NRDC Comments on ENERGY STAR Lamp Specification – Version 2.0 Draft 1

Noah Horowitz Director, Center for Energy Efficiency Standards Natural Resources Defense Council (NRDC) <u>nhorowitz@nrdc.org</u>

March 12, 2015

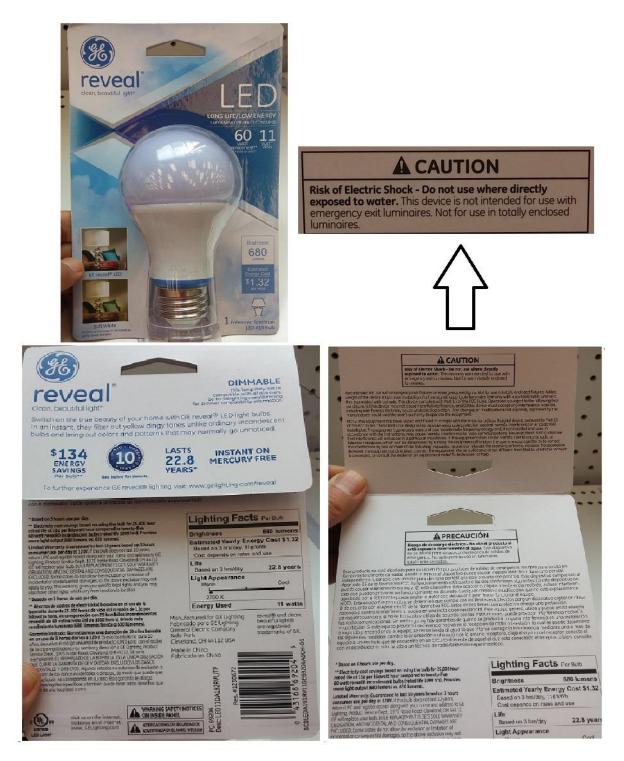
NRDC found the lamp packaging requirements contained in Section 15.2 that relate to enclosed fixtures insufficient. While we agree that lamps not suitable for use in a totally enclosed fixture should be required to contain a warning label on the package, the ENERGY STAR specification is devoid of any requirements regarding the location of such a claim or its visibility (e.g., minimum font size, contained within a warning box, etc.). Below we show two examples of

woefully inadequate warning claims which have a very low probability of being seen or acted upon by a consumer as they are not located on the front of the package and can only be found amongst lots of fine print on the back panel.

The first example shown below is for an LED omni-directional lamp² where the front of the package does not include any text regarding the suitability of usage in an enclosed fixture and the warning that does exist is found at the last line of the caution box on the back stating not for use in an enclosed luminaire. Given all the fine print on the back of the box and the fact that few if any consumers are familiar with the term luminaire, this warning will likely be ignored.

- a) Require "Not for use in a totally enclosed fixture" type language to be printed on the front/main panel of the package for lamps that do not meet the elevated temperature testing requirements; and
- b) Establish a minimum font and other appropriate graphics requirements to increase the visibility for this warning and the probability it will influence consumer decision making.
